# Improved design

Redraw

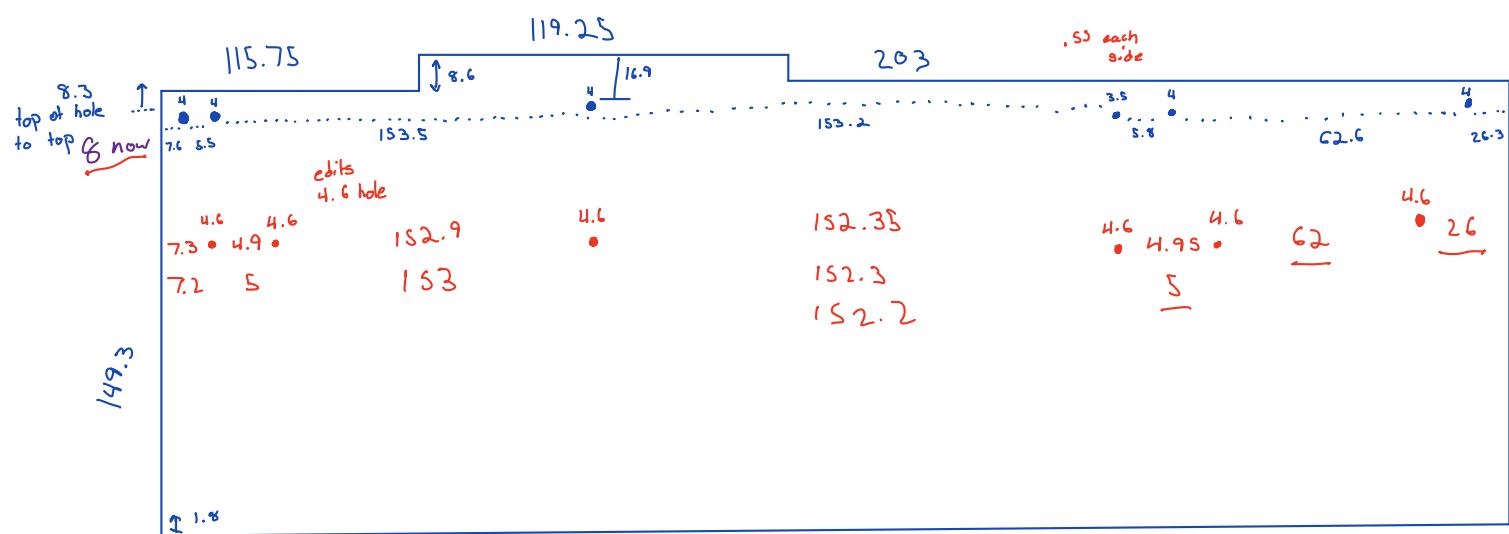
two types of holes : type 1 4x4 mm  
type 2 / don't res

Note, holes on original board seem to be inconsistent, will make holes slightly bigger and improve consistency

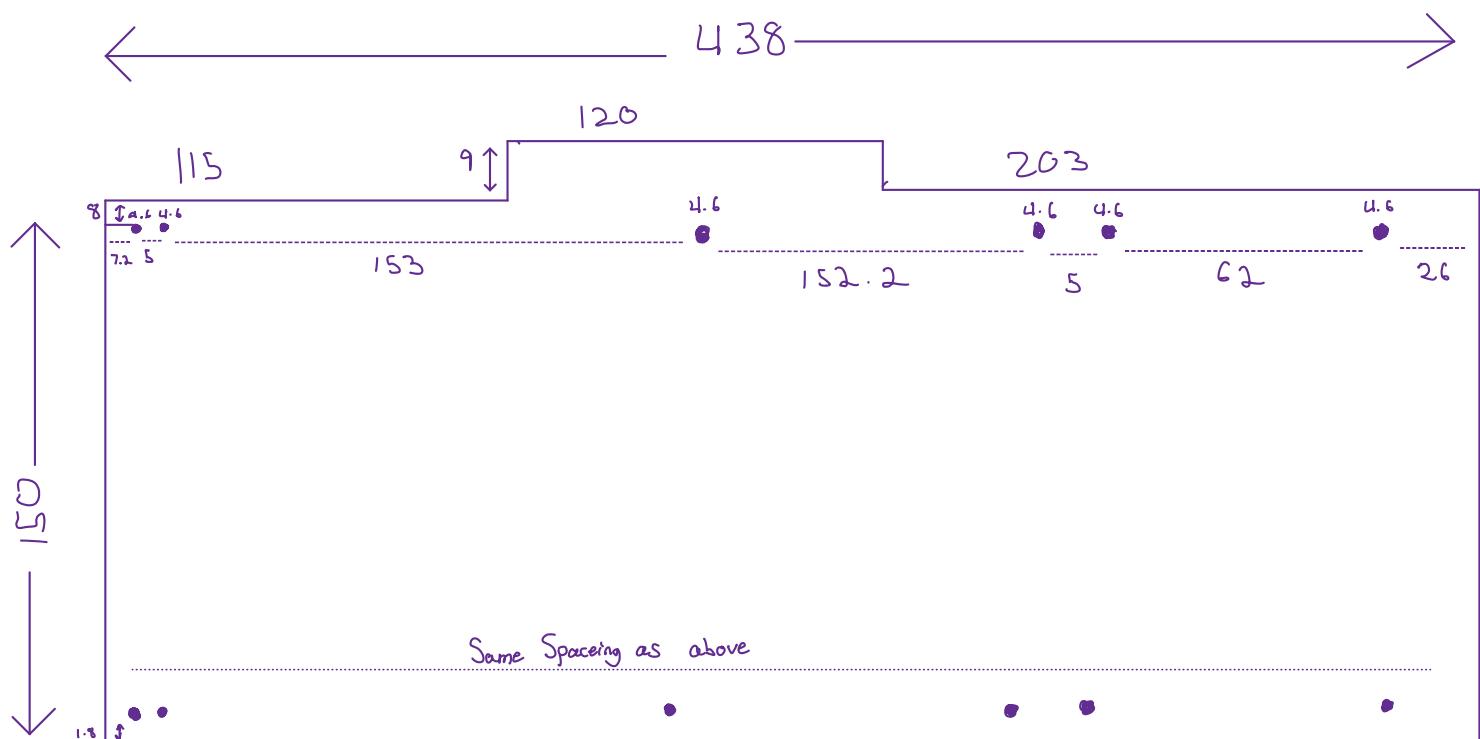
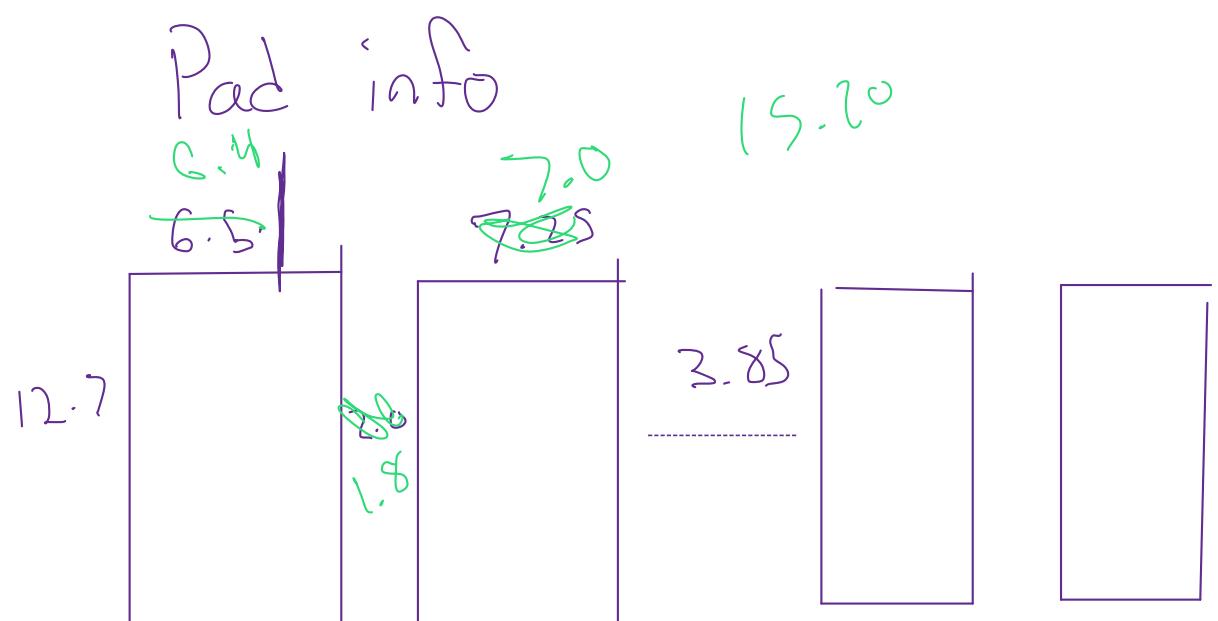
note: evened out lengths, made each hole 4.6mm

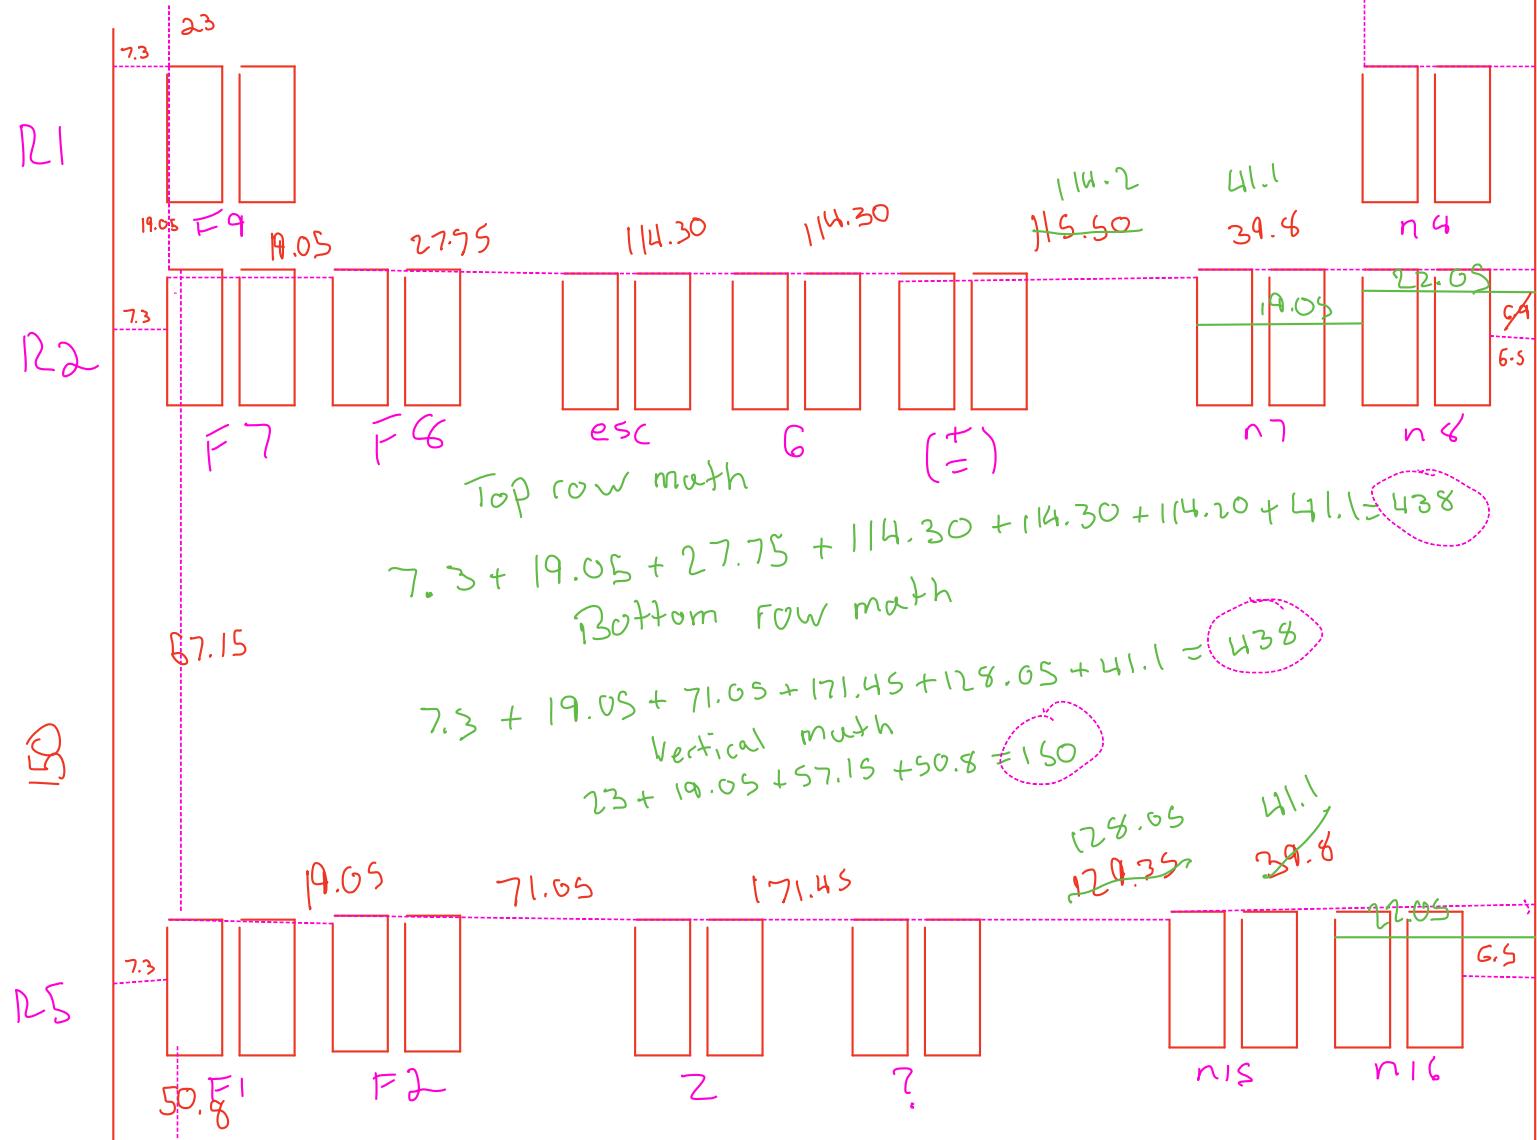
The right block has fucky pos<sub>s</sub>, I will fix  
green is corrections

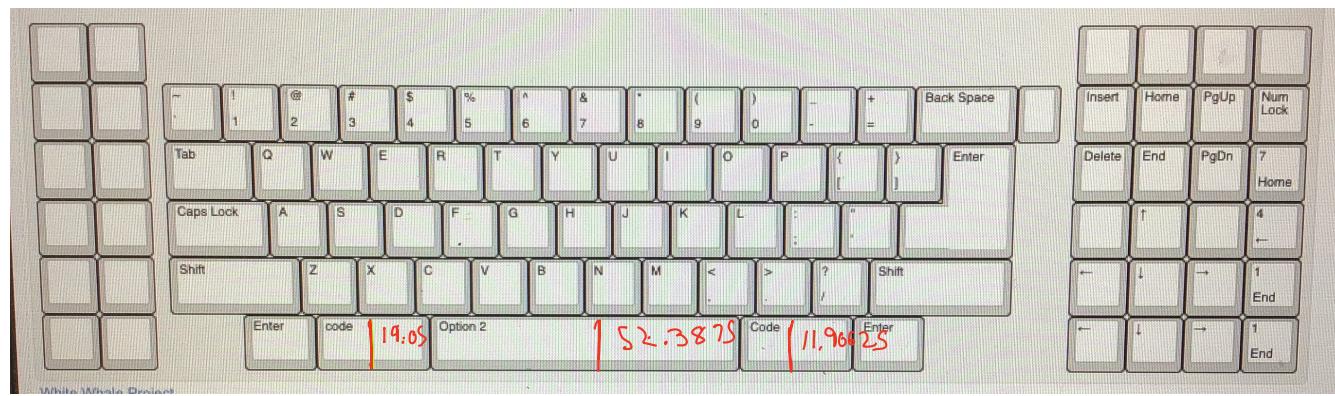
Spacing is very strange?

Math 71.4375  
measure 71.6  
2 off

math - 64.3  
measure - 65.2  
9 off  
(flipped  
Pad  
Correct)
